PRE-BID ADDENDUM
Cuba Township Office Renovation
28000 W Cuba Rd, Barrington, IL 60010

APA PROJECT #	25-023	**DATE ISSUED**	10/16/2026
ADDENDUM NO.	002	**BID DUE**	10/21/2026
OWNER	Cuba Township	**ISSUED BY**	APA

This Addendum forms part of Bidding Documents and modifies or clarifies them as described below. Bidders shall acknowledge receipt of this Addendum on the Bid Form.

1 FIRST FLOOR DEMOLITION PLAN
3/16" = 1'-0"

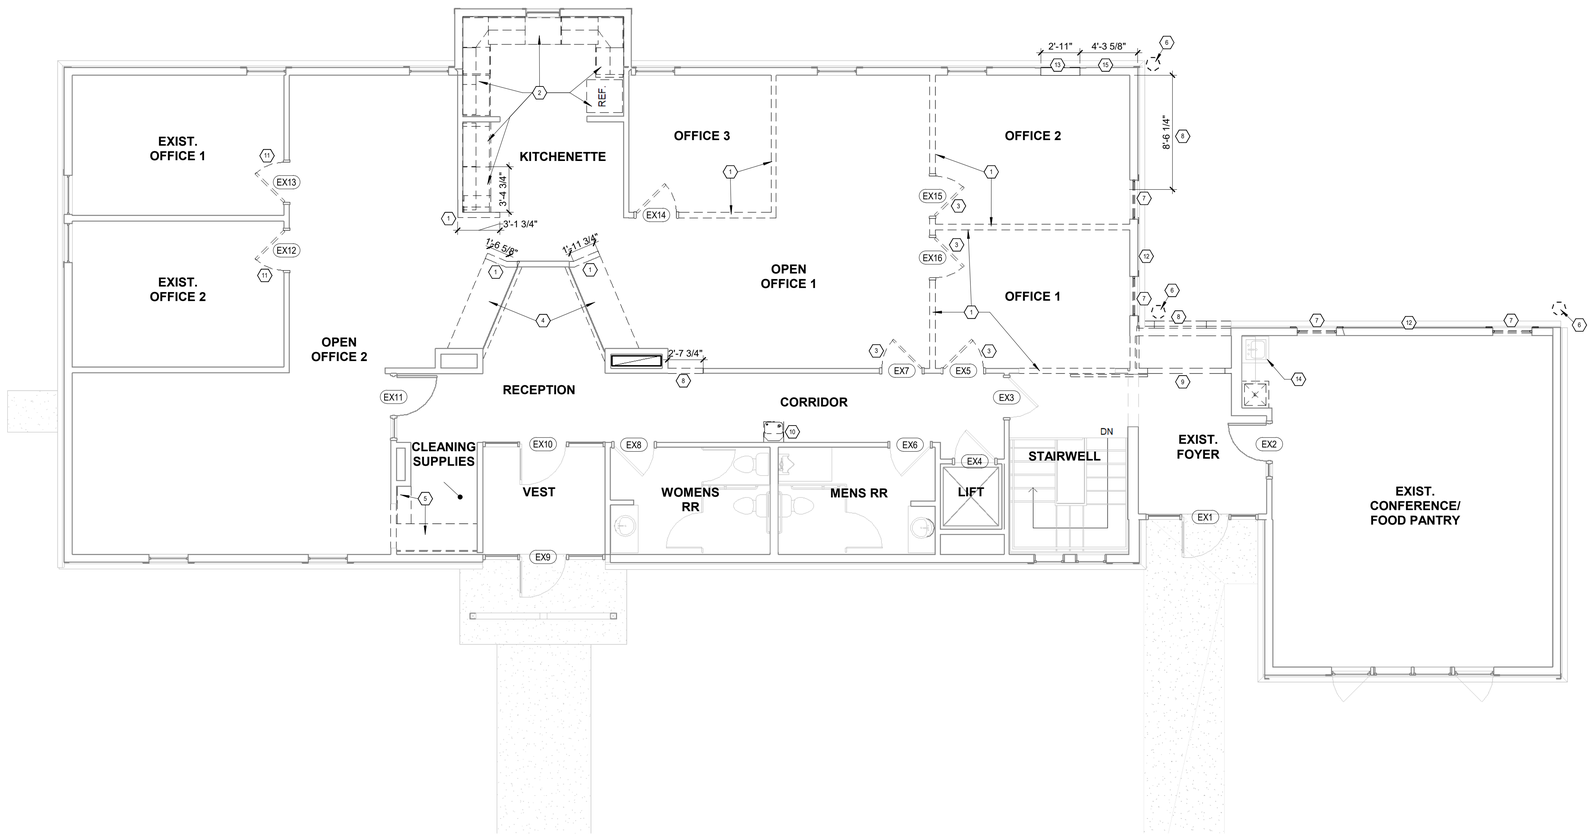
13. **Question:** Please confirm scope of demo offices note on A0-1. Demolition plan. Does this include demolishing existing flooring or just the walls and ceilings at the demolished walls?

14. **Question:** Please confirm construction of existing exterior walls to be demolished for new windows per A0-1.
    Answer: yes, existing exterior wall must be demolished to the extent shown to accommodate new window. See A0-1 in the updated set for more details.

15. **Question:** Please confirm construction of existing interior walls to be demoed including height.
    Answer: All existing interior walls to be demoed are as indicated on A0-1 and must be demoed in its entirety (floor to ceiling) UNO.

16. **Question:** Please confirm the kitchen cabinet demolition. The demolition plan appears to show that only half of the existing cabinets will be removed.
    Answer: All kitchen casework must be demolished. Sheet A0-1 is updated accordingly

17. **Question:** Please confirm whether the entry wall and countertop are to be demolished and clarify the extent of the demolition.
    Answer: A portion of entry wall and the entire reception countertop must be demolished. Sheet A0-1 is updated accordingly

Answer: Please refer to sheets A0-1 & A0-2. The demolition will include existing flooring, walls and ceiling light fixtures as indicated. The ceiling and existing walls to remain must be repaired /patched to receive new paint.

1 PROPOSED FIRST FLOOR PLAN_A
3/16" = 1'-0"

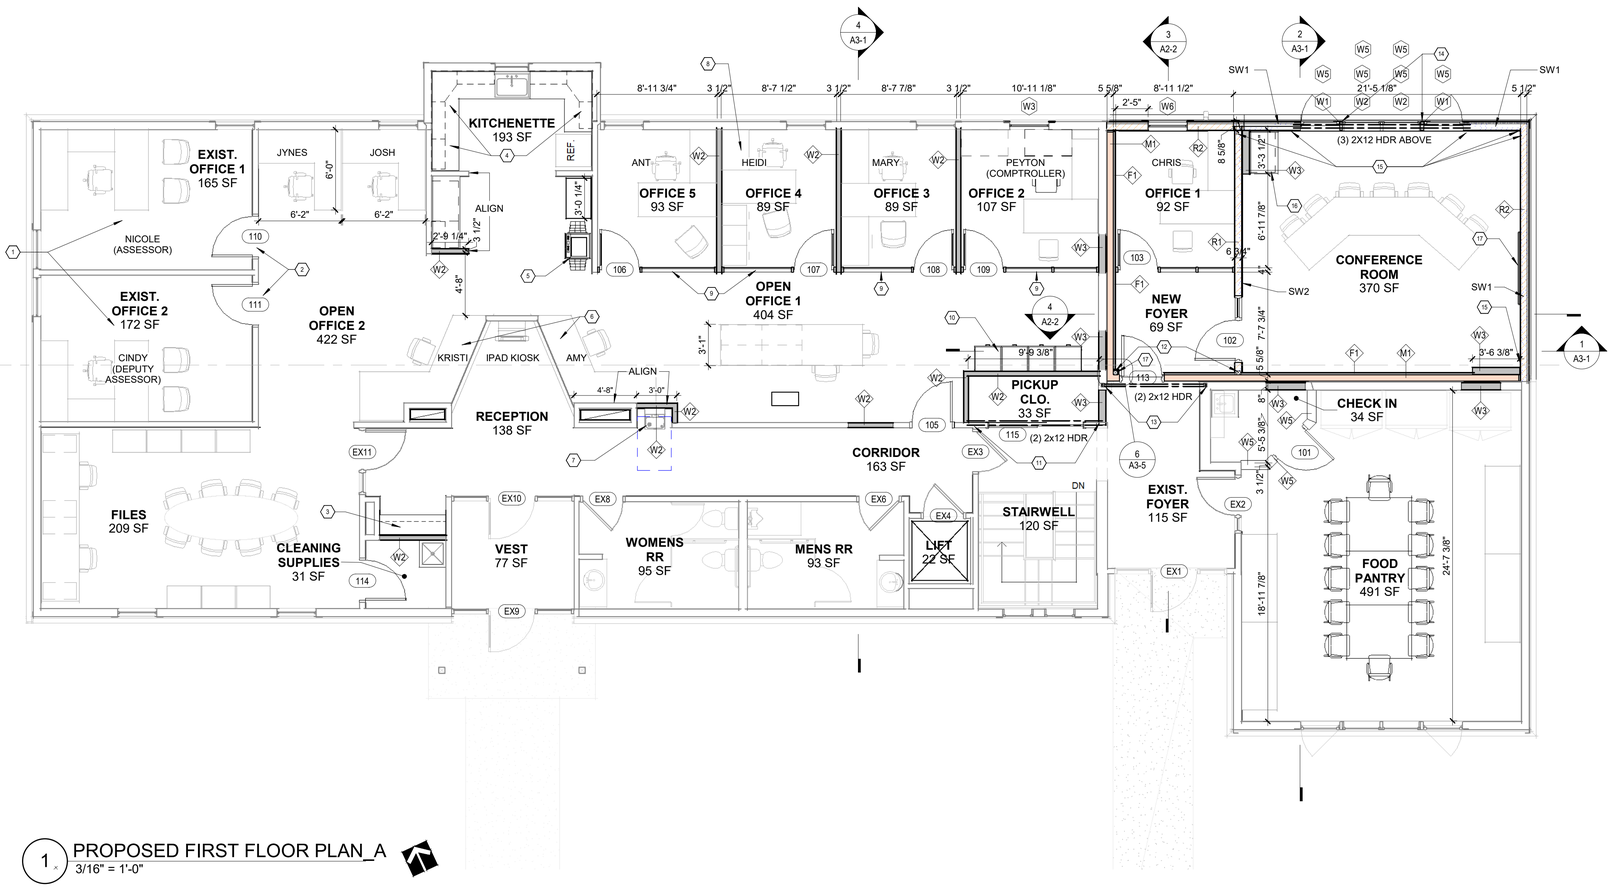
20. **Question:** A1-1. Please confirm wall type at pick up clo.
    Answer: A1-1 updated.

21. **Question:** A1-1. Confirm if fireproof filing cabinets are by owner.
    Answer : All furniture including desks,chairs,storage cabinets will be by Rieke Interiors. There scope of work also includes procuring & installing glass office partition walls, all casework as well.

22. **Question:** A1-1. Confirm copier is by owner.
    Answer: Yes, copier is by the owner.

37. **Question:** A4-1-WALL TYPES-WALLTYPE M-1- G1. Details are not shown.
    Answer: See updated sheets A1-1 & A4-1 for more details

1 PROPOSED BASEMENT FLOOR PLAN
3/16" = 1'-0"

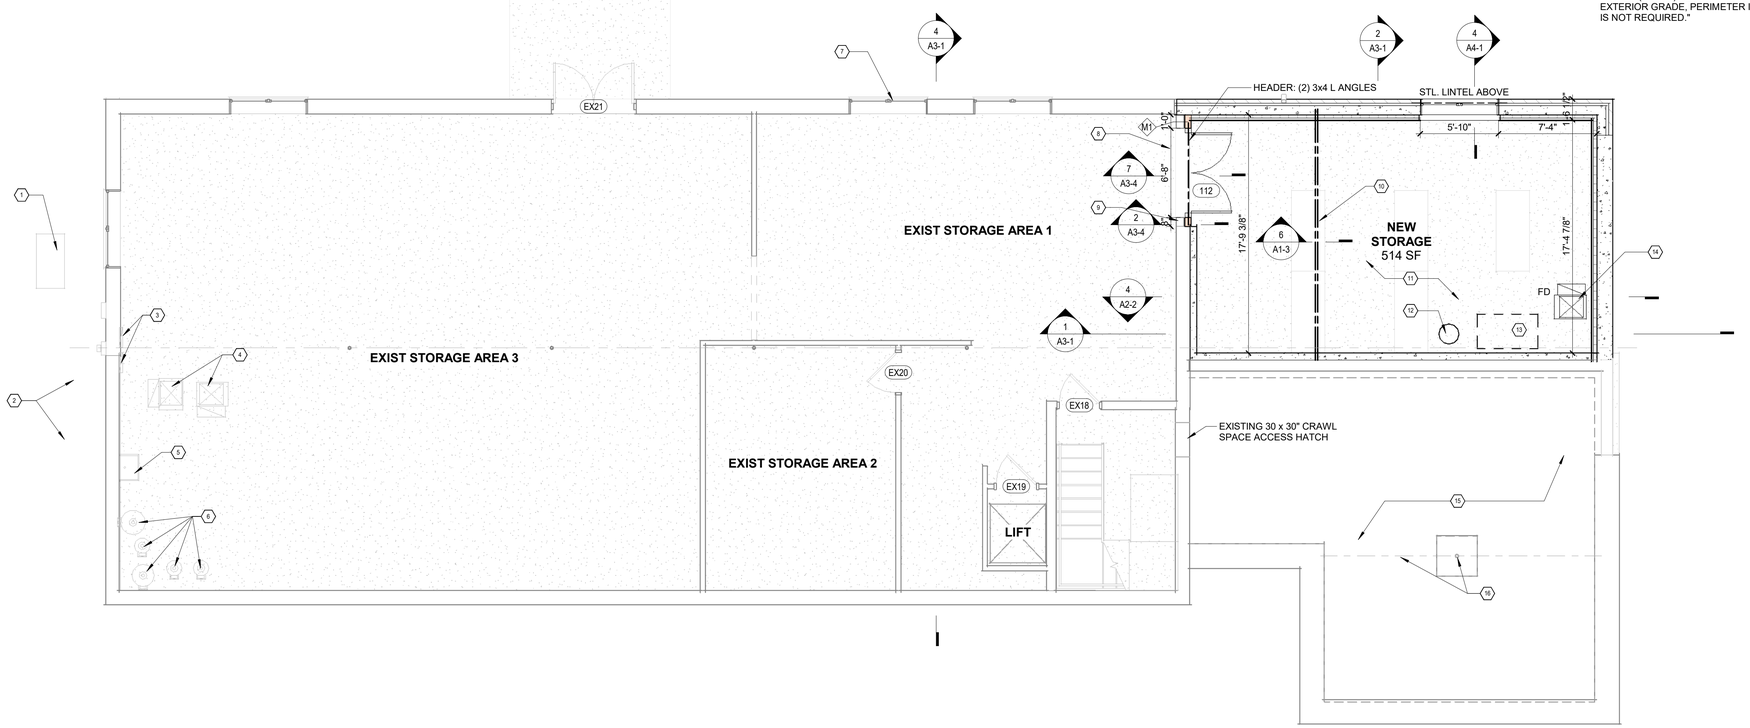
27. **Question:** A1-2 Confirm 30" x 30" crawl space hatch is new and if so please provide specification and installation detail.
    Answer: Its an existing crawl space access that will remain.

28. **Question:** A1-2 Confirm if new fire water tank and pump require a 4" housekeeping pad.
    Answer: No, the fire tank and pump do not need housekeeping pads

29. **Question:** A1-2. Provide specifications and piping diagram for new floor drain.
    Answer: See plumbing drawings for details

30. **Question:** A1-2. Please confirm thickness of existing foundation wall for new door sawcut.
    Answer: GC to verify in field.

1 ADDITION FOUNDATION PLAN
1/4" = 1'-0"

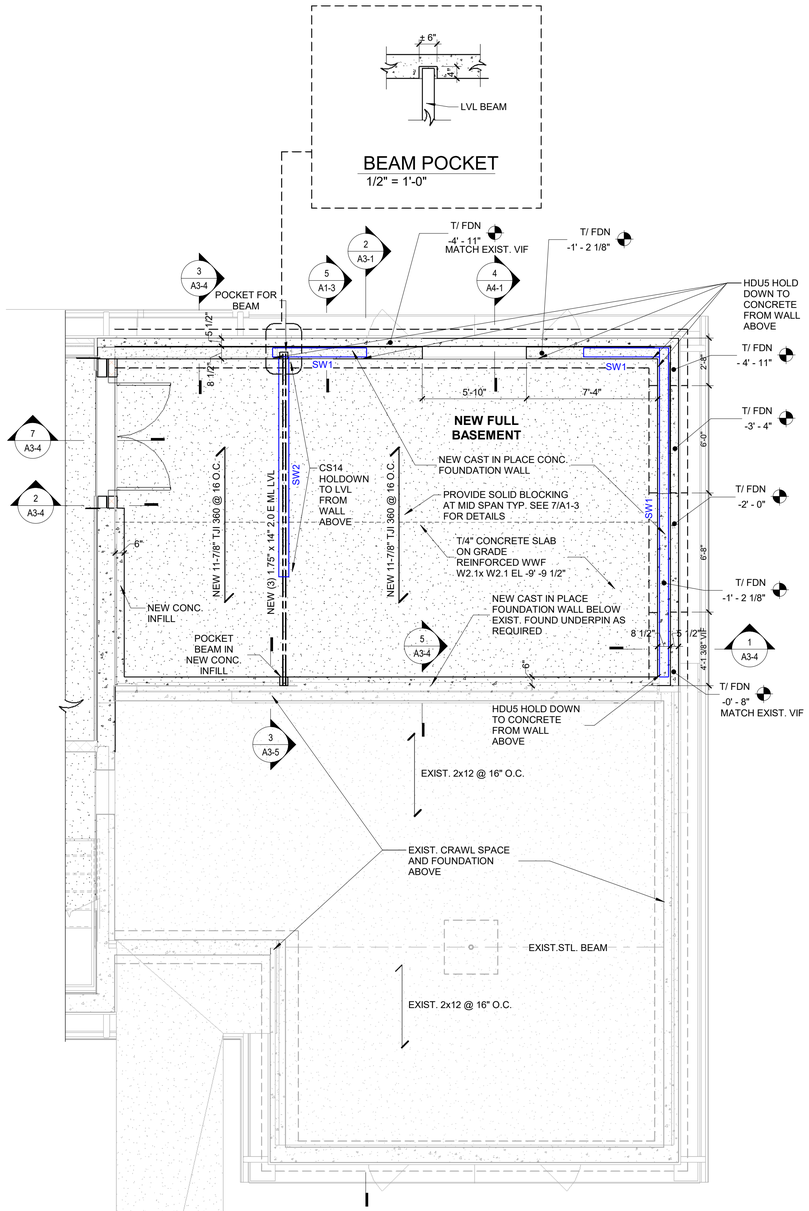
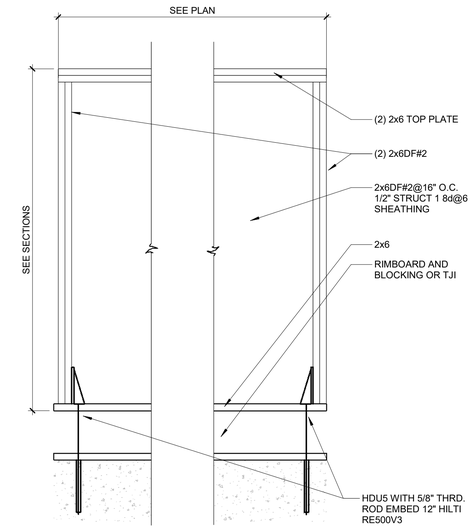
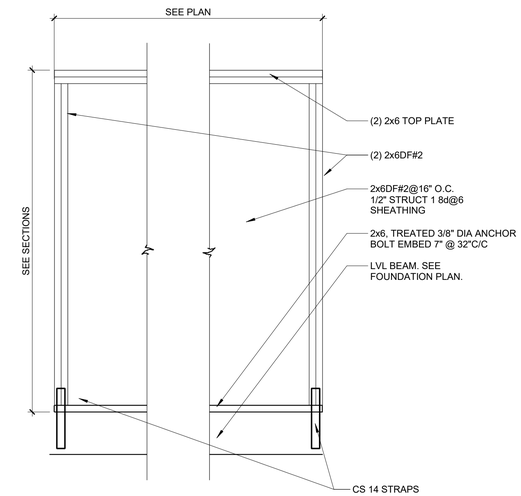
24. **Question:** A1-1. What are SW1- SW2?
    Answer: They are shear walls. Refer to sheet A1-3 for more details.

31. **Question:** A1-3. Mid span blocking is drawn. TJI floor joists should not have/need mid span blocking. If blocking is still required by structural engineers, they need to specify the material and provide a drawing detail on how they want this done.
    Answer: Mid span blocking must be provided for improved floor performance. See 7/A1-3 for more details

1 SOUTH ELEVATION
1/4" = 1'-0"

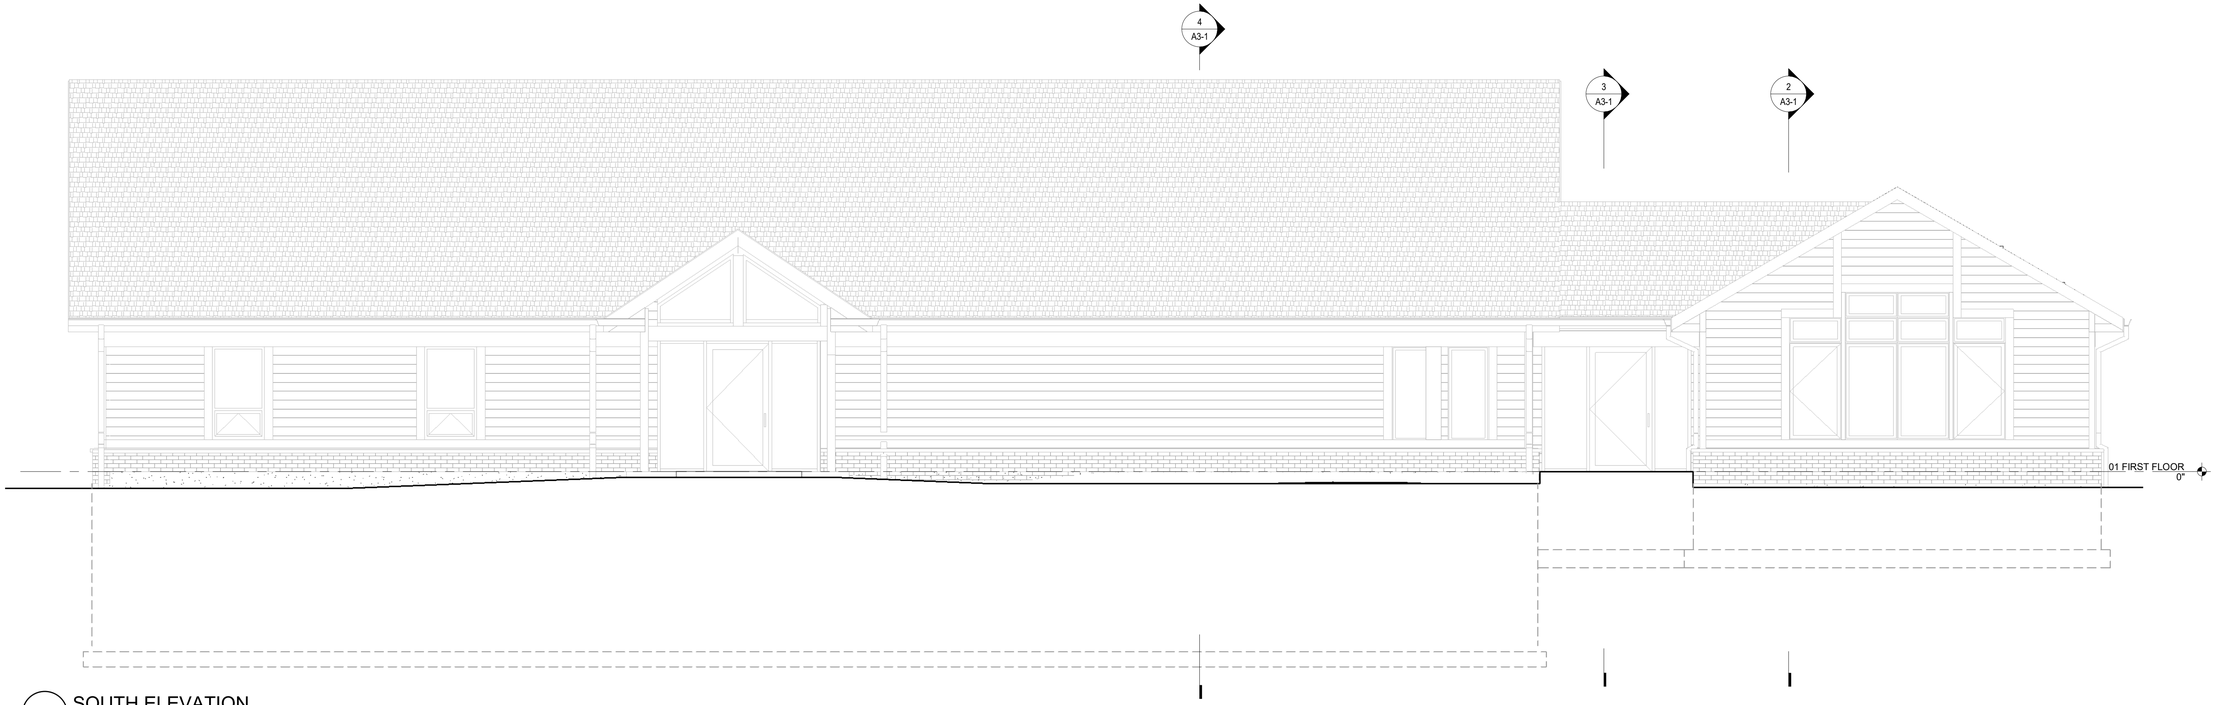
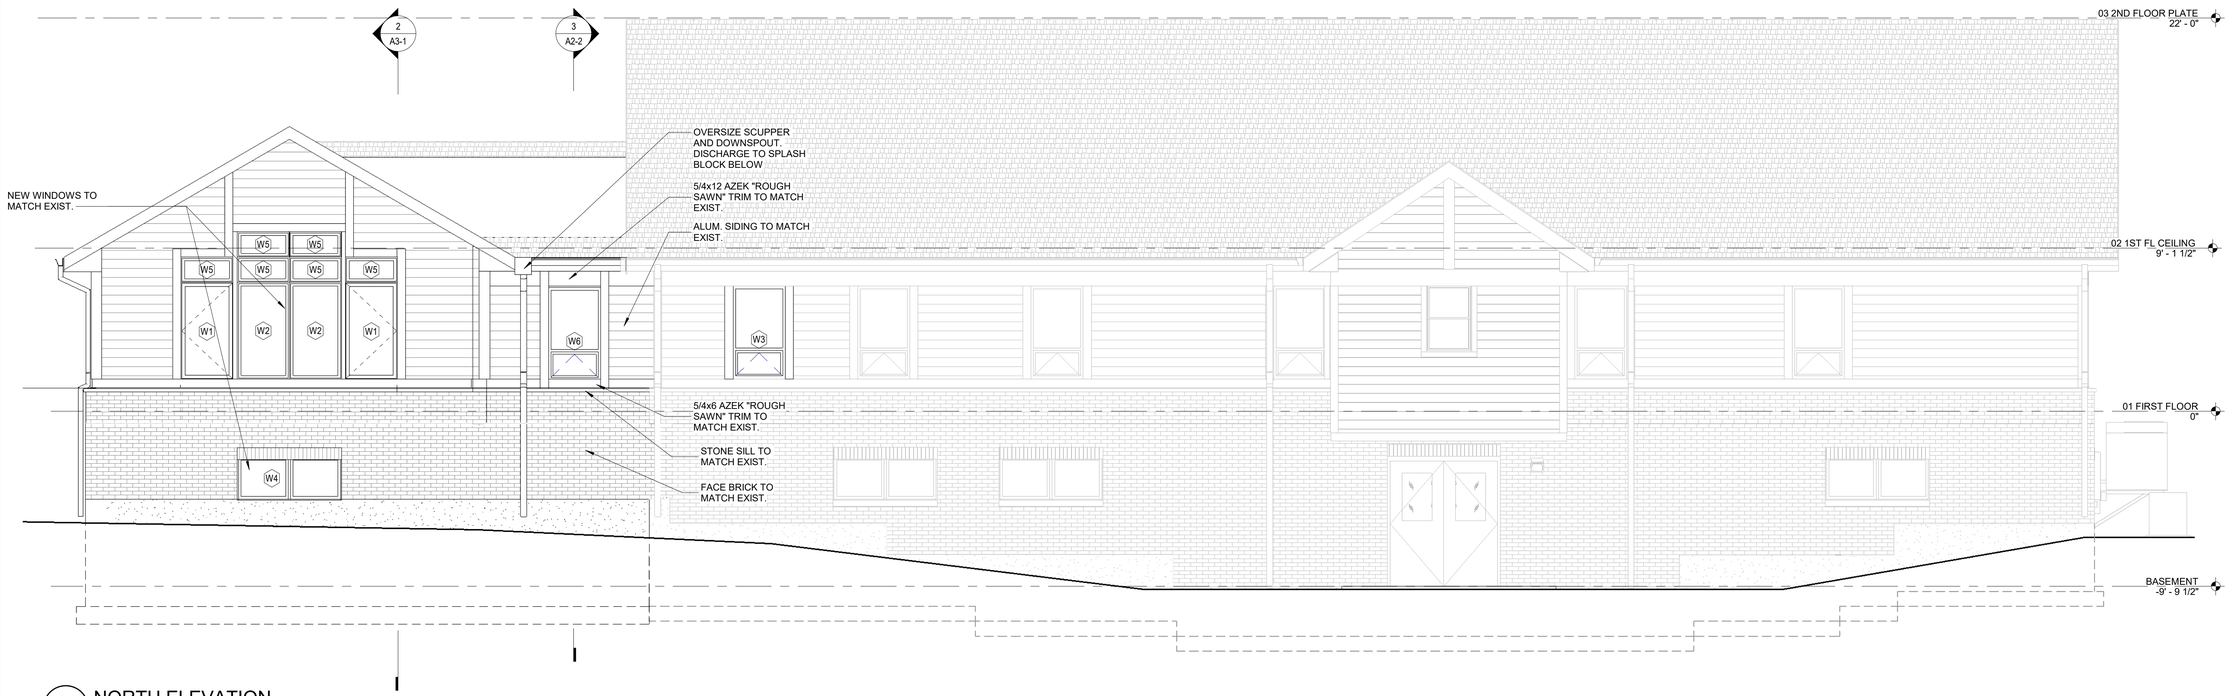
1. **Question:** Just looking at the siding, is it the intent to have all metal siding per rendering or face brick per elevation. Please advise
   Answer: 2/A2-1 has been updated to show the correct façade finish.

4 FIRE WALL DETAIL 1
1 1/2" = 1'-0"

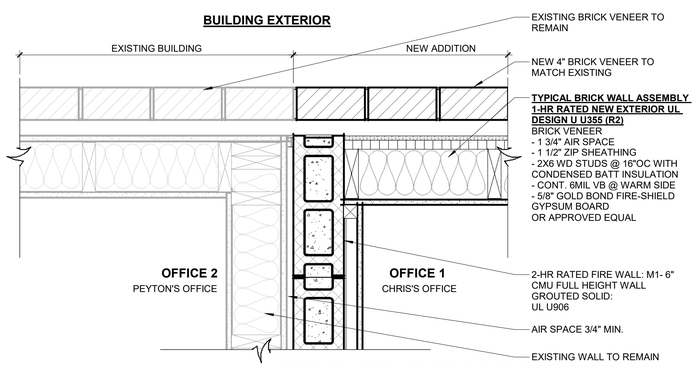
36. **Question:** 4/A3-5. Please confirm if an expansion joint will be required at new to existing brick veneer, if so, please provide detail.
    Answer: Provide a vertical expansion joint at the intersection of the new and existing brick veneer. Provide a 3/8" wide continuous joint with compressible backer rod and exterior-grade elastomeric sealant. Do not mortar across the joint. Maintain continuity of the weather-resistive barrier and flashing behind the joint. Refer to revised Detail 4/A3-5 for additional information.

NOTE:PROVIDE A VERTICAL EXPANSION JOINT AT THE INTERSECTION OF THE NEW AND EXISTING BRICK VENEER. PROVIDE A 3/8" WIDE CONTINUOUS JOINT WITH COMPRESSIBLE BACKER ROD AND EXTERIOR-GRADE ELASTOMERIC SEALANT. DO NOT MORTAR ACROSS THE JOINT. MAINTAIN CONTINUITY OF THE WEATHER-RESISTIVE BARRIER AND FLASHING BEHIND THE JOINT.

WALL TYPES
1" = 1'-0"

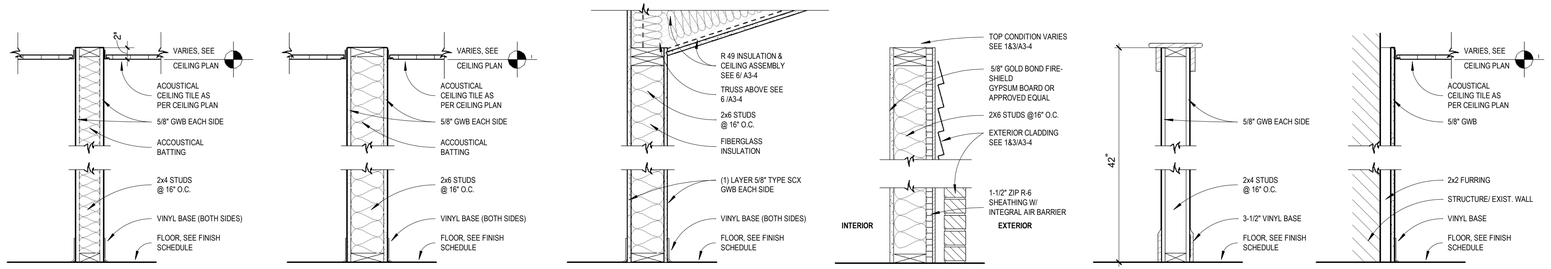
25. **Question:** Wall type R1 is called out as 2x4 framing, but SW2 is called out as 2x6. This is conflicting as part of the R1 wall is shear wall 2. Which size is correct?
    Answer: R1 is supposed to be 2X6 framed wall. A4-1 updated accordingly

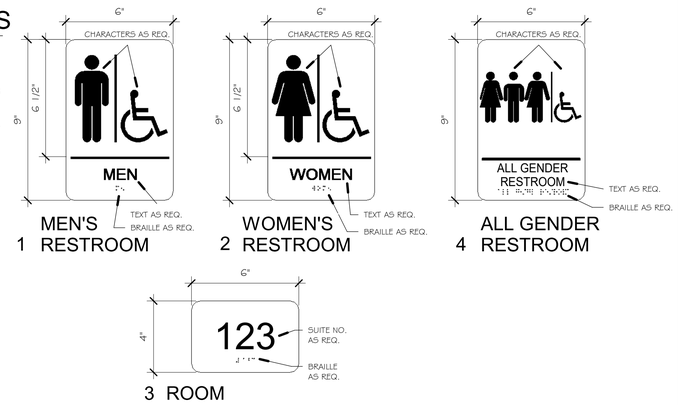
39. **Question**: A4-2 door schedule calls for Dr 113 to be Hardware set 1, Hardware schedule calls for Dr 113 to be Hardware 6
    Answer: Hardware 6 is correct, Schedule updated accordingly.
